Central Bus Tracking Project Site 1: Carlton Street

Detailed Design Safety Audit

Date: June 2018
Reference: OAS 2018-083 MR
Status: Version 1

Figure 1 : Tapered Edgeline on Approach to Side Island

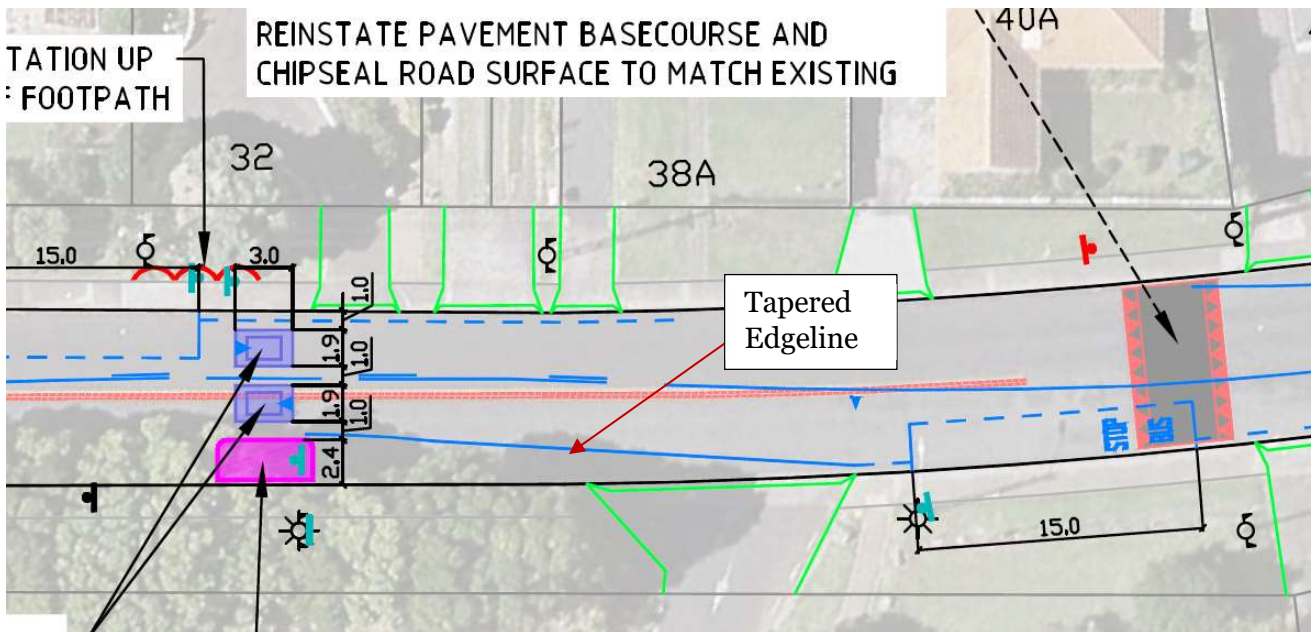
The SAT is concerned with the delineation of the entry taper on the westbound approach to the proposed side island. Visibility of the tapered white edgeline on the approach to the side island may decrease during wet or dark conditions. Poor visibility of the tapered edgeline may direct motorists towards the side island during wet or dark conditions. The delineation of the entry taper could be improved by installing mono-directional red Reflective Raised Pavement Markers (RRPMs) on the edgeline.

Consider installing mono directional red RRPMs along the tapered edgeline.

Figure 2 : Pinch Point Adjacent to Bus Stop

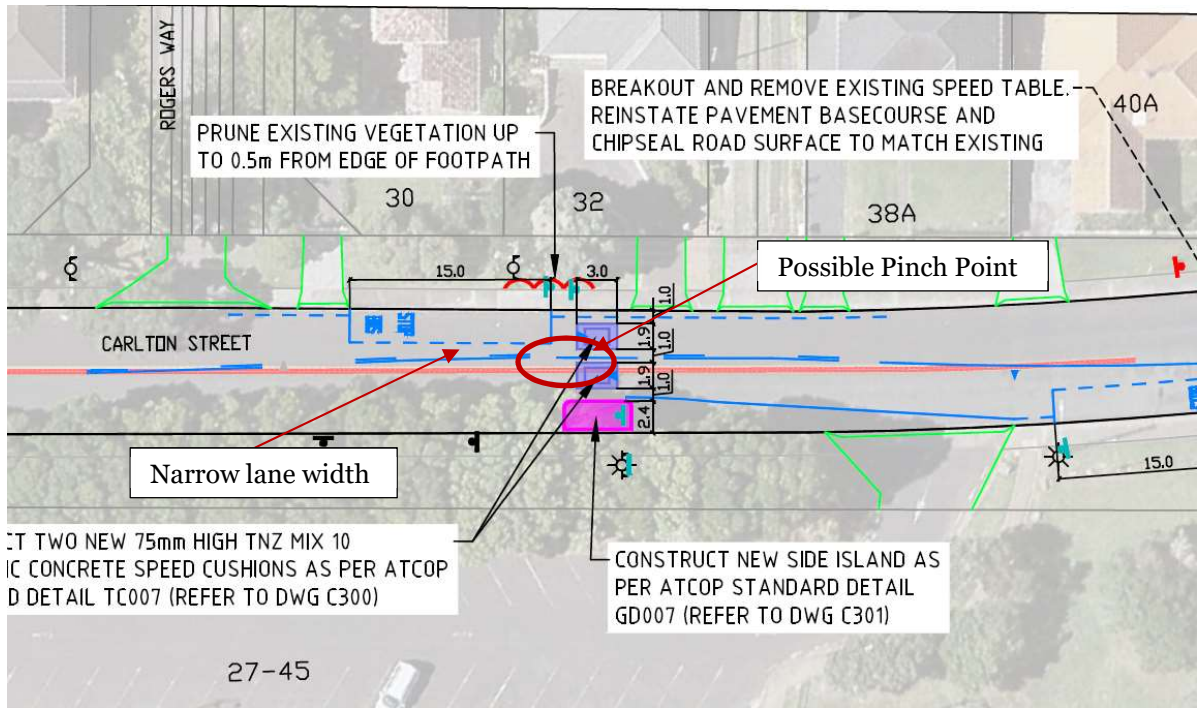
The SAT is concerned with the proposed location of the bus stop adjacent to 30 Carlton Street. The bus stop creates a narrow lane width for eastbound motorists. This is exacerbated by the close proximity of the side island to the bus stop which creates a pinch point for motorists. The bus stop should be relocated further to the west of the side island to avoid the formation of a possible pinch point for motorists.

Consider relocating the bus stop away from the side island to avoid the formation of a possible pinch point for motorists.
